Type Coffee Vending Machine	Model 9100 – 9200 - 95	N° T.I. 13 - 2019
Serial Number 94110295	Subject New "24 V + PVB" mixer motor	ISSUED FOR (X) Action Information X

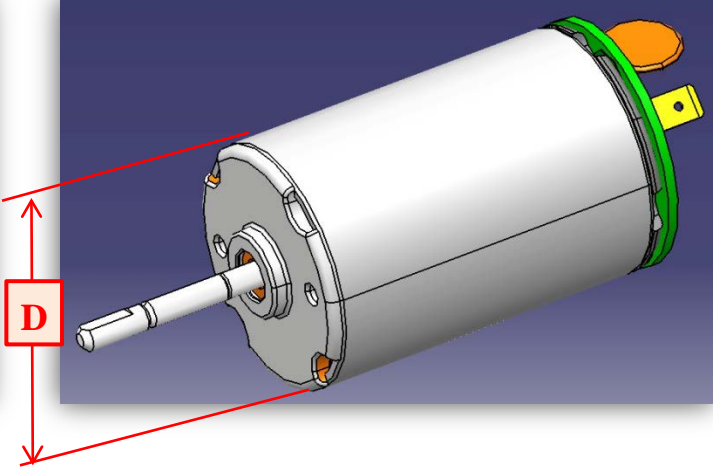
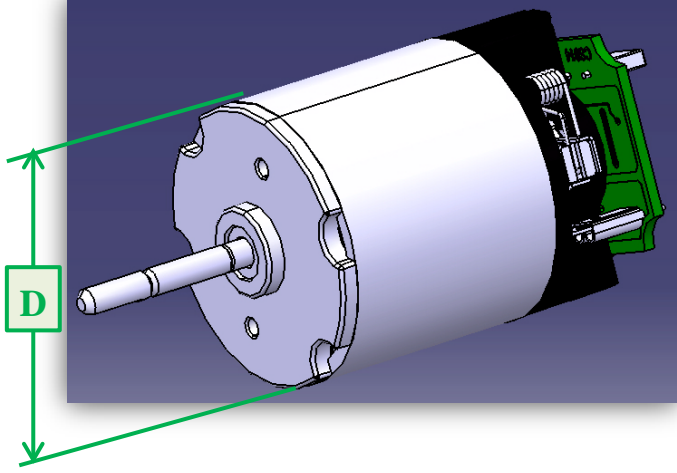
The "24 V + PCB" **mixer motor** has been replaced by a new one

New "24 V + PCB" mixer motor
Body **D. 40 mm**

Pre-modification "24 V + PCB" mixer motor
Body **D. 36 mm**

- The **new mixer motor** differs from the **pre-modification** only in the diameter of the body
- The **spare code** is not changed: **260795**

For machines previous to above **S/N** it's possible to use the **new mixer motor**.
